# 1276 GLADSTONE AVENUE PROPOSAL

**Re: rezoning and development proposal for 1276 Gladstone Avenue**

**Folder #: CLC00414**

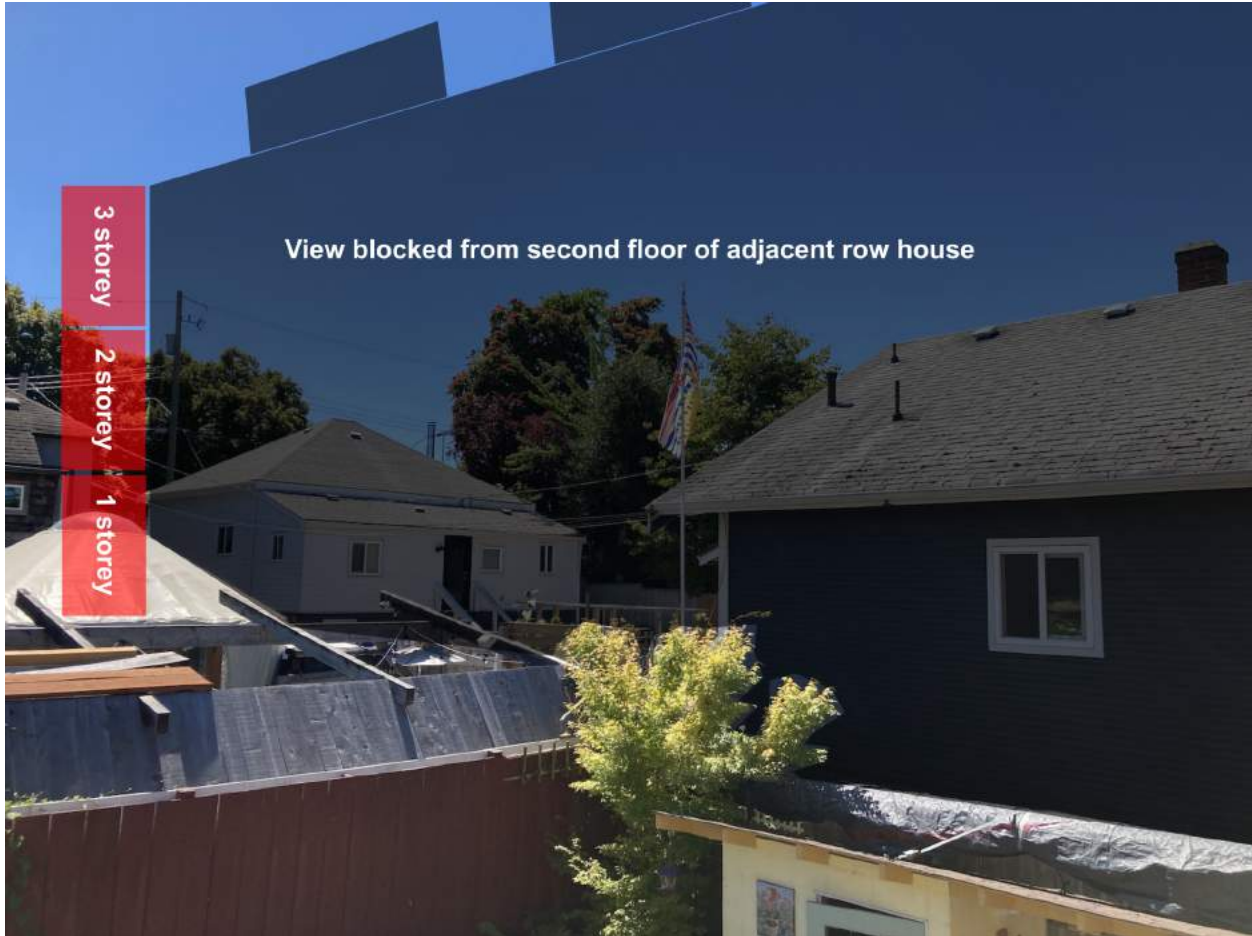
The development would also block for many neighbours a cherished and valuable siteline to the Belfry Theatre. The FDGV notes, in section “2.2 Character Defining Elements,” that one of the core “character-defining elements” governing the design guidelines is to acknowledge the importance for views of the Belfry, noting that “Views of the Belfry Theatre’s spire [serve] as a landmark, focal point and visual terminus” for the surrounding neighbourhood (FDGV, 7).

The development as proposed would terminate the Belfry view for a significant number of surrounding properties, as shown in the following diagram.

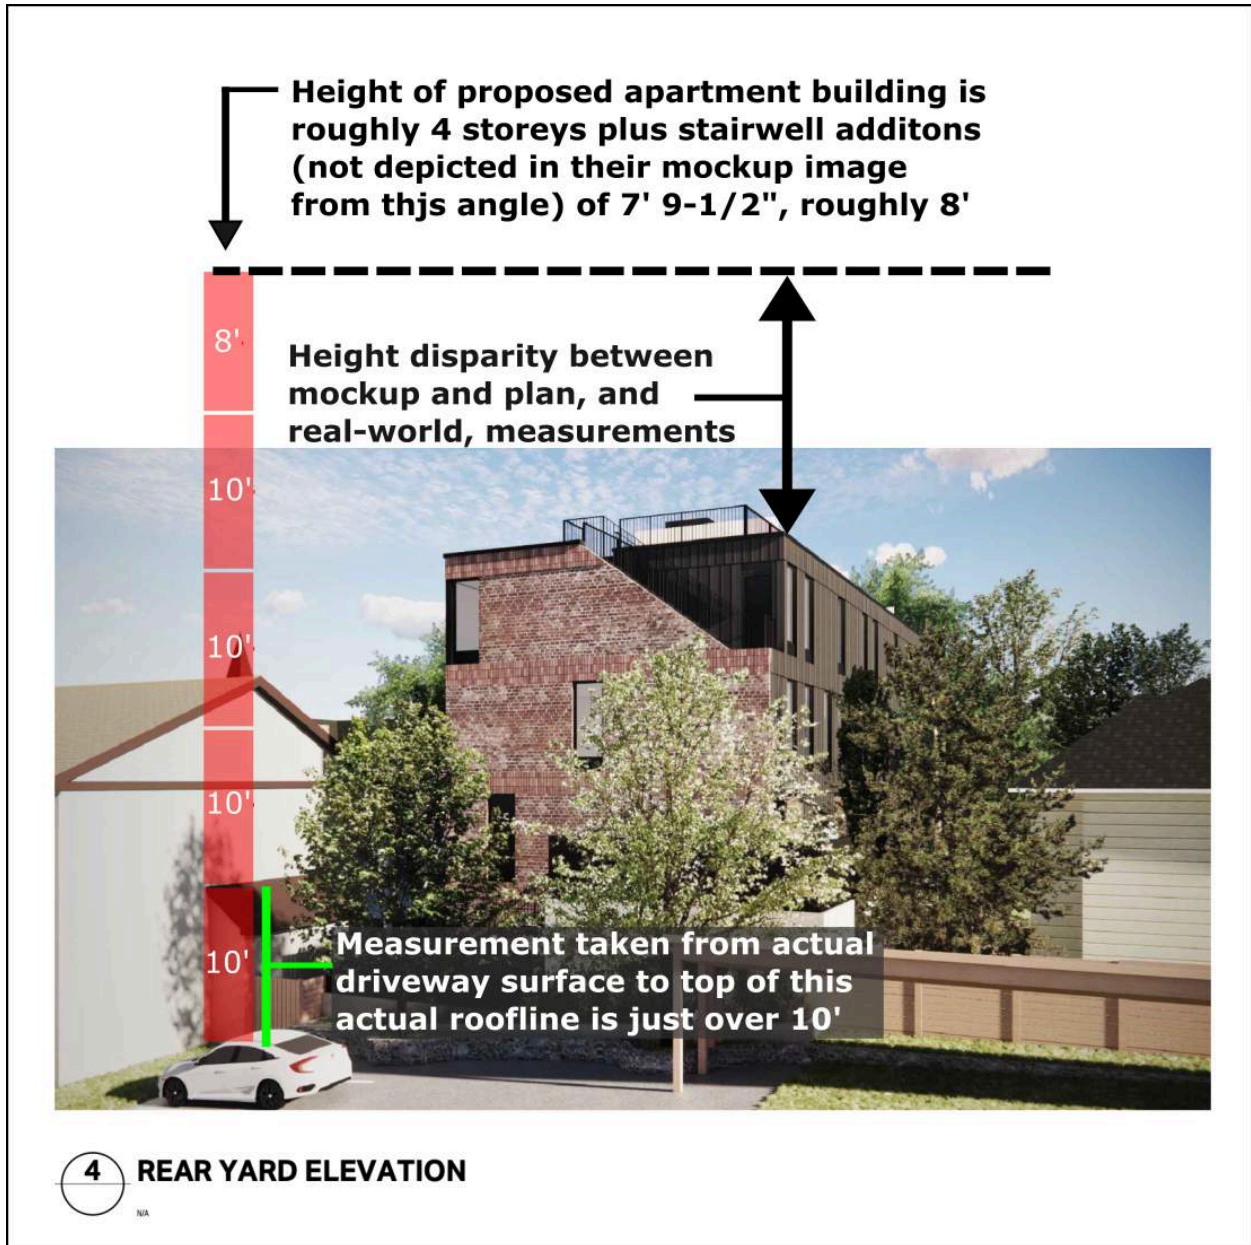
Note that the image above also shows that 1276 Gladstone property is toward the top of a rise. Our co-op housing unit (which sits directly to the east, or left, in the above image) has a backyard that sits roughly 2-2.5m (6-8') below average grade on the 1276 Gladstone lot.

Turning to the revised mockup of the same view, the height distortion in the mockup reduces drastically the relative peak of the roof height on the proposed development.

**2 SOUTH ELEVATION**

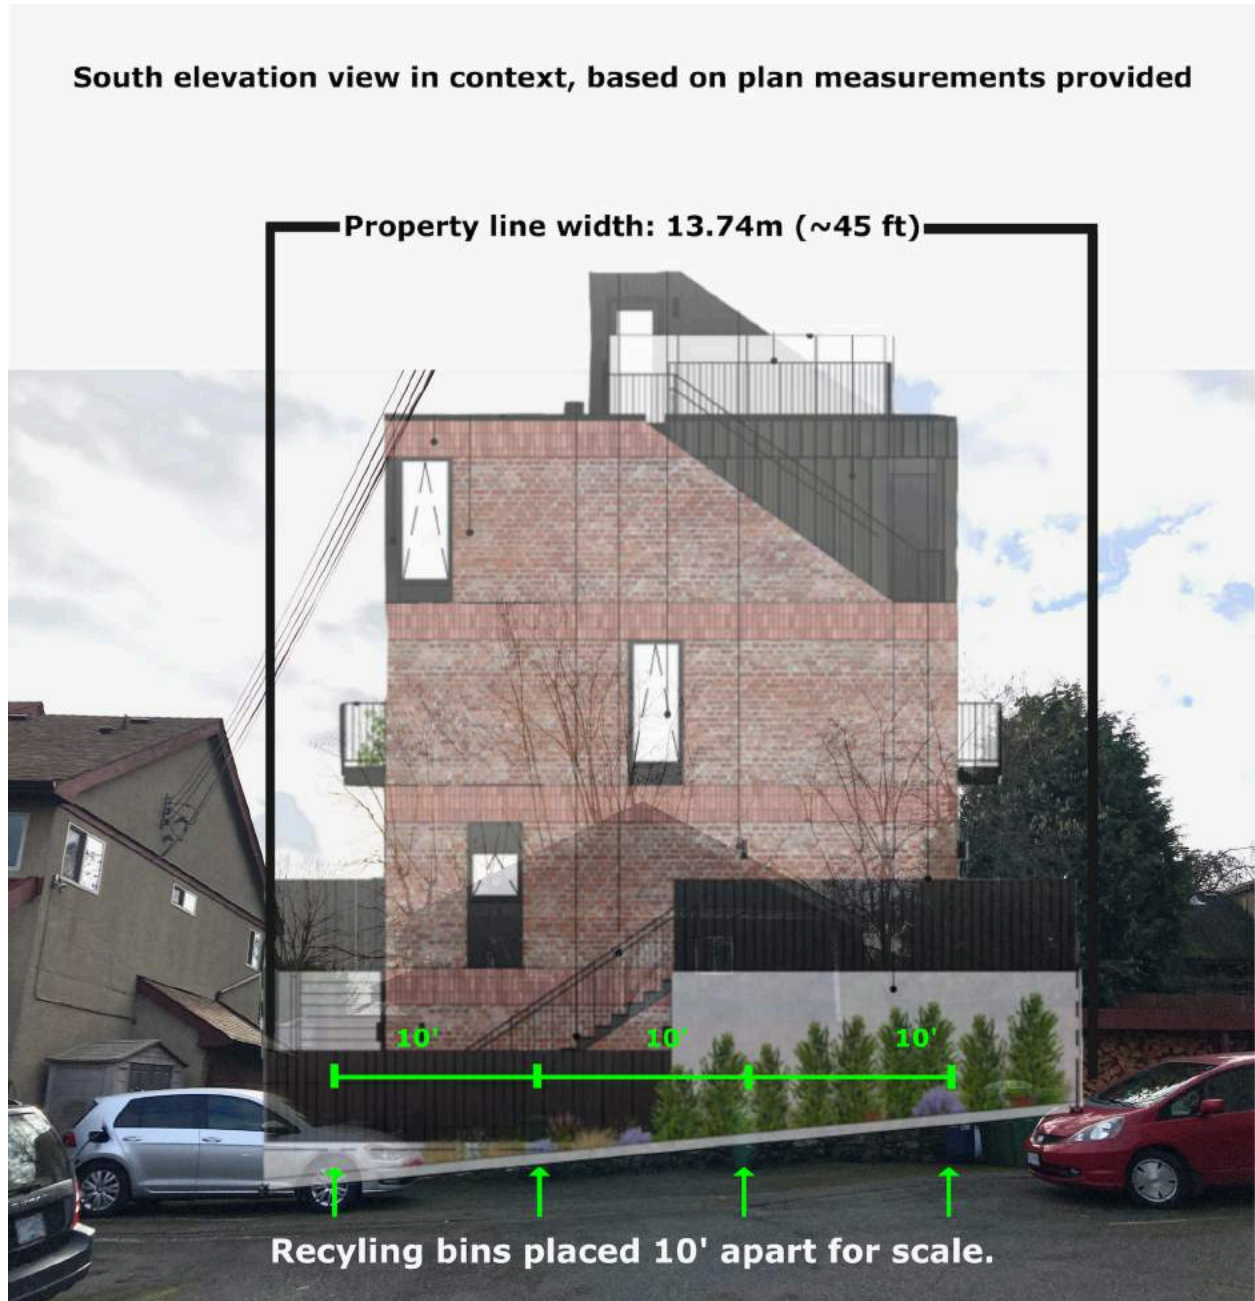
The development proposal's only face-on, north-side mockup image, "South Elevation" (2023-12-13 - Plans\_Revisions.pdf, p, 16), is presented without any surrounding buildings, making it impossible to visualize its scale relative to the surrounding properties:

The “Front Elevation,” or south-side mockup (p. 18), however, does depict the building in context with the surrounding buildings. Showing this view in context makes sense from a persuasion perspective; after all, the front face of the building, at 3 storeys, looks relatively smaller than the south elevation image:

Adjusting for the in-place scale of the northern property line, and using the measurements in the developers' plan, this is a more accurately scaled view of the South Elevation mockup:

Note that the opacity of the south elevation image is adjusted to show the existing house (1278 Gladstone), the roofline of which appears relatively short compared to the house to the east because the 1278 Gladstone sits closer to Gladstone than the proposed building, which pushes to within 1m of the northern property line.

Shown in context, it is clear that the proposed design is too large for the space. The Fernwood Community Plan—the City’s own guideline document for this area—calls for any new developments to “provide diverse living options at **neighbourly scales**, including through the retention of character homes through conversion” (19) [my emphasis].

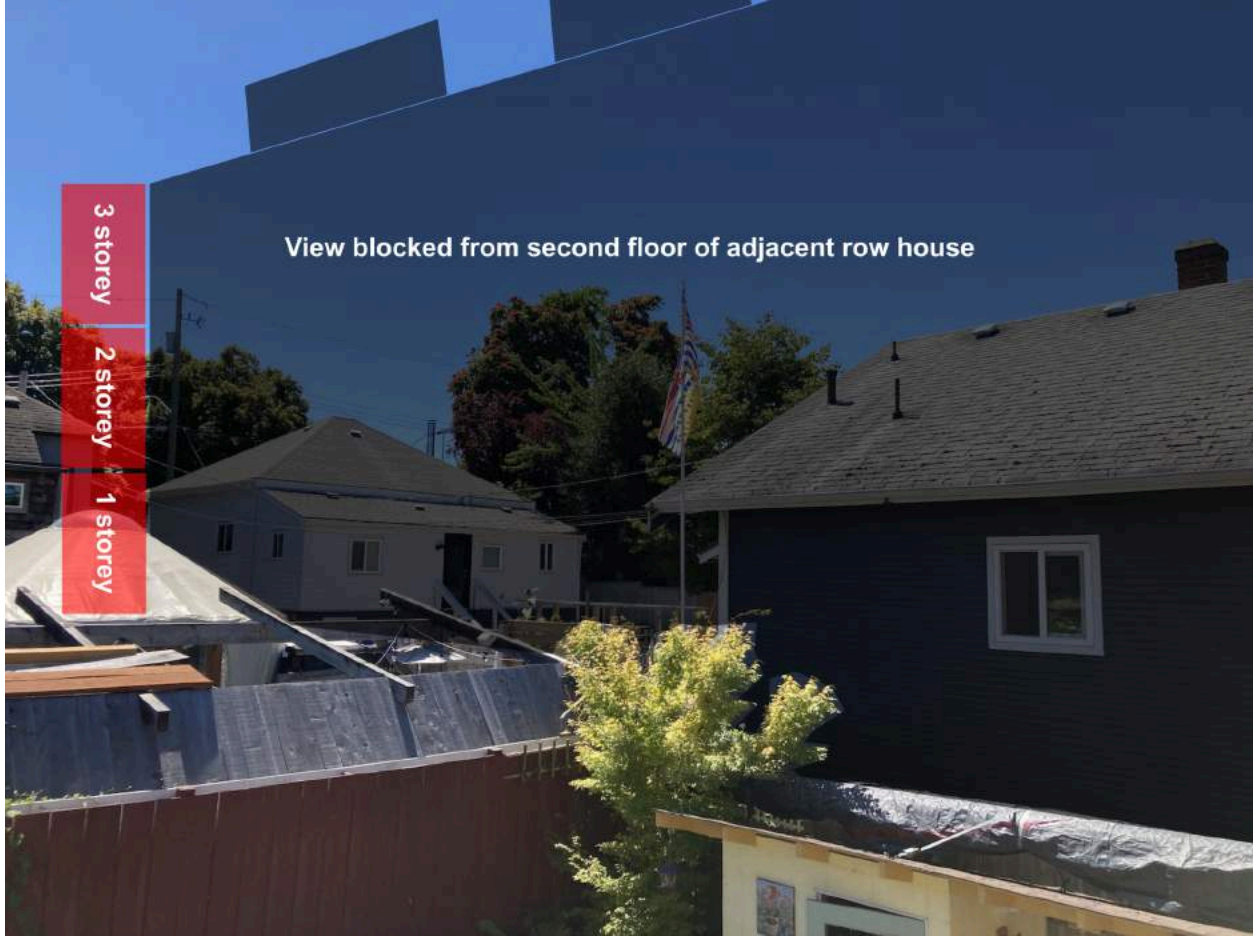
On page four of the 2023-12-13 - Letter to Mayor and Council.pdf, the developers acknowledge “concerns over building height and shade impact” and make the following adjustment to the plan:

the rooftop access stair closest to the rear yard has been removed and replaced with an exterior stair at L4, resulting in a stepped massing and reduced shade impact on neighbouring properties to the north.

This change is hardly significant, and particularly ineffectual for the buildings to the east and west, those most affected by the shade and privacy impacts of the build. In other words, none of their design changes address the “shade impact” to the east and west.

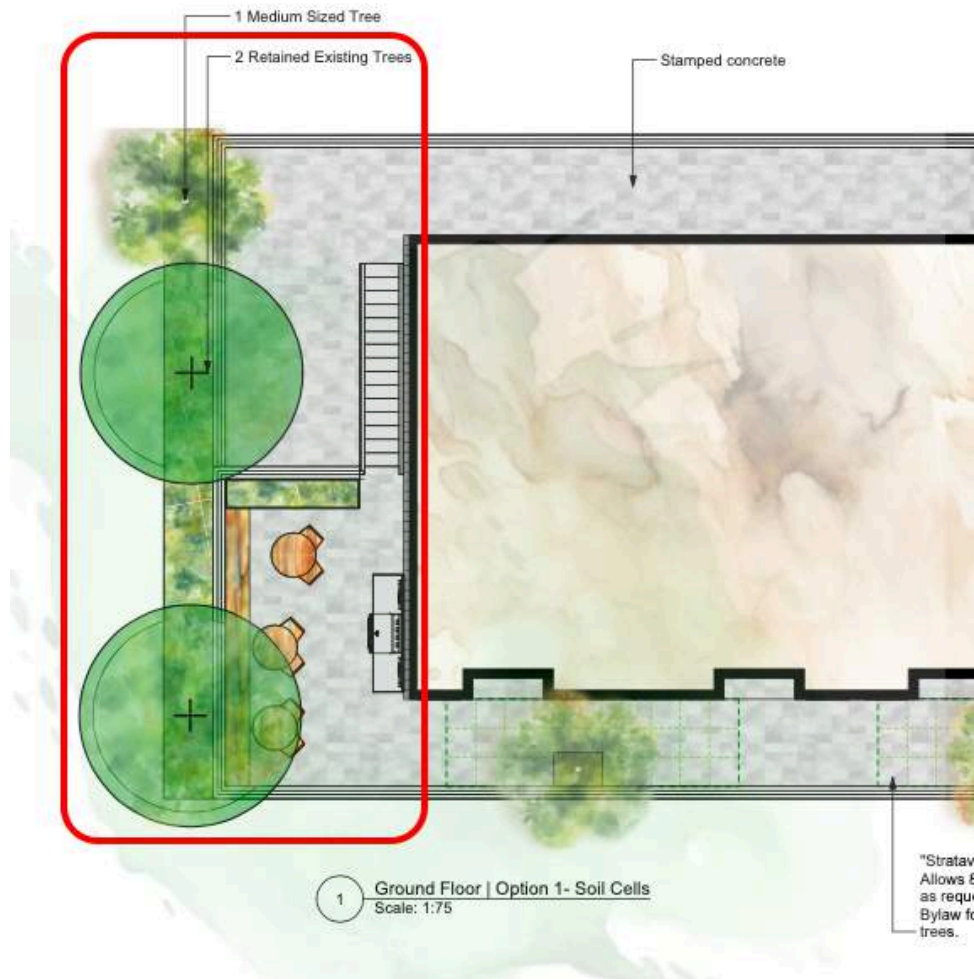
The first appeal noted that page 31 of the first submitted design plan indicates the retention of existing hazelnut trees, suggesting that these trees are part of the development property, as seen in the following image:

As mentioned in the first appeal, these trees shown in the design are not on the 1276 Gladstone property: they are on the other side of the 1275 Pembroke property, as can be seen in the following image:

The first appeal noted concerns the building's foundations would affect the roots of these hazelnut trees. The revised design threatens these trees all the more. The concrete walls proposed for the north end of the 1276 Gladstone property will require digging down to hardpan in order to be engineering compliant—as a result of this digging, the roots of the hazelnut trees will be irreparably damaged and the trees will likely die.

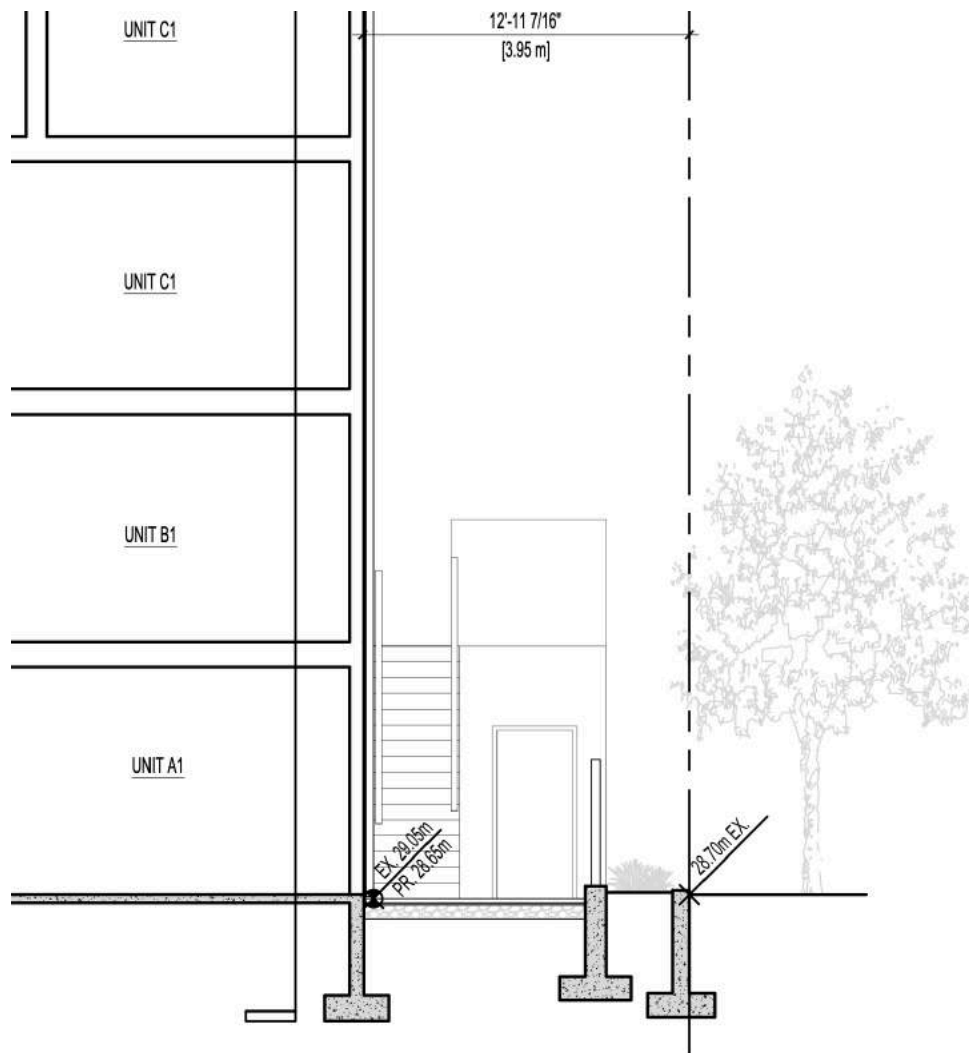
Looking at the architectural drawings, note the proximity of the retaining wall and footings to the symbolic hazelnut tree in the following image:

This rendering is concerning, also, because it misrepresents the scale of the trees (there are two, not just one) and their proximity to the northern property line. This is easy enough to correct for with an image of the architectural depiction:

## Approximate tree height line relative to proposed apartment building

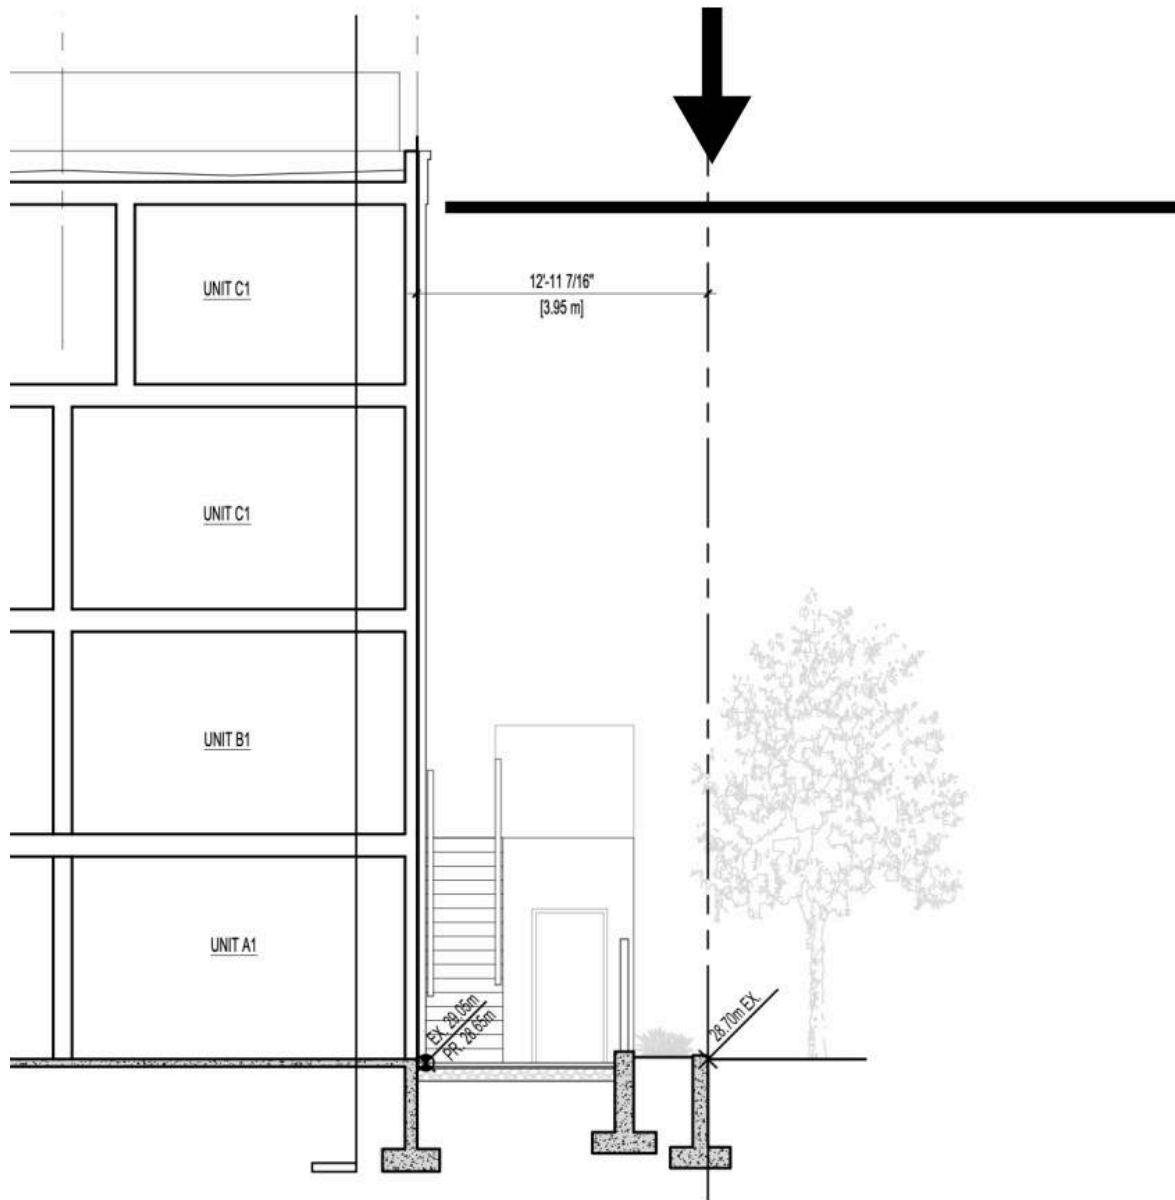
Height-adjusted, the hazelnut tree reaches roughly the fourth floor of the proposed apartment building:

From looking more closely at the site, it appears that it is not possible to build the retaining walls without disturbing the tree roots and ultimately destroying these trees. These trees are a living and thriving community asset, and so another arborist's report should be undertaken in light of the design changes.

## Dealing with retaining walls

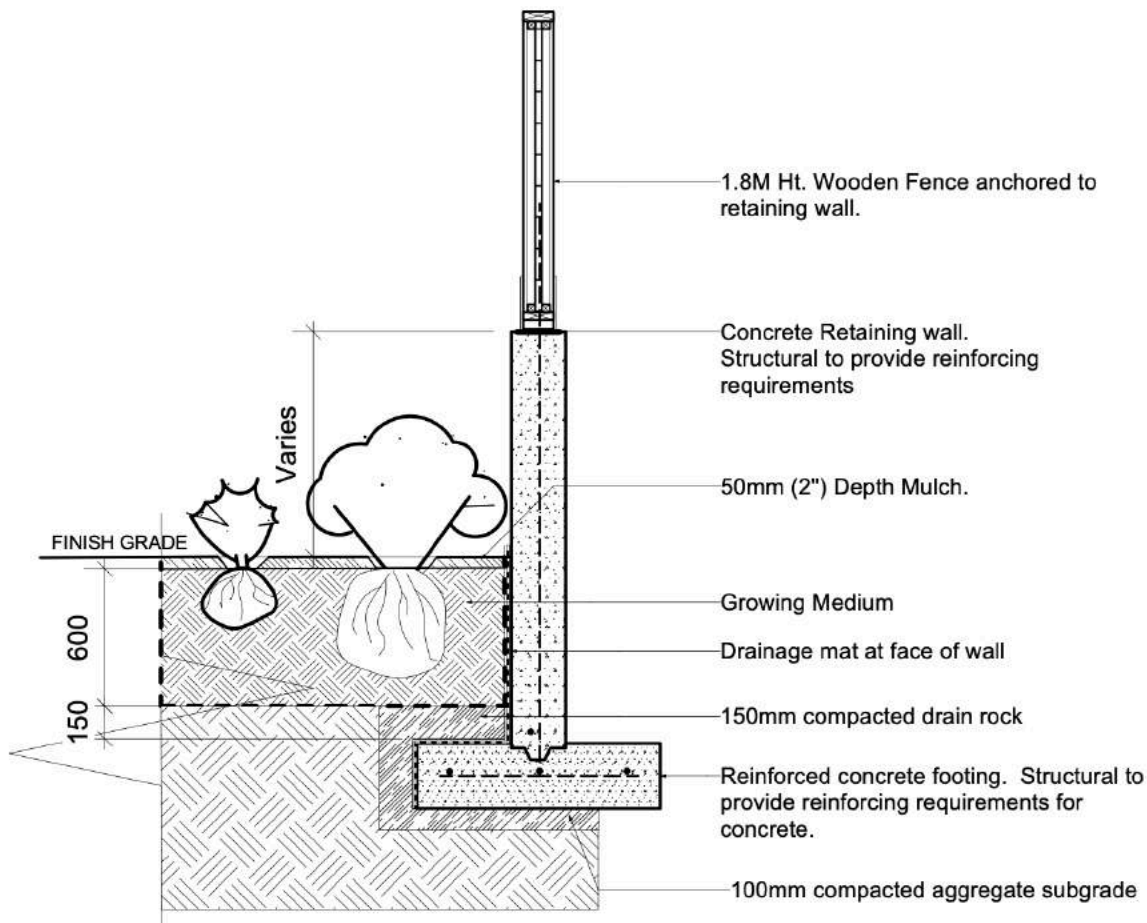
Page 20 of 2023-12-13 - Plans\_Revisions.pdf indicates a "1.8 m Ht. Cedar Privacy Fence" along the east edge of the property line. This same page shows a design schematic that includes a retaining wall, to which the cedar fence is affixed.

What the plans fail to show is that the eastern run of the property line already has a partial retaining wall and an existing fence, along with California Lilac hedges grown from seedlings over that last four years.
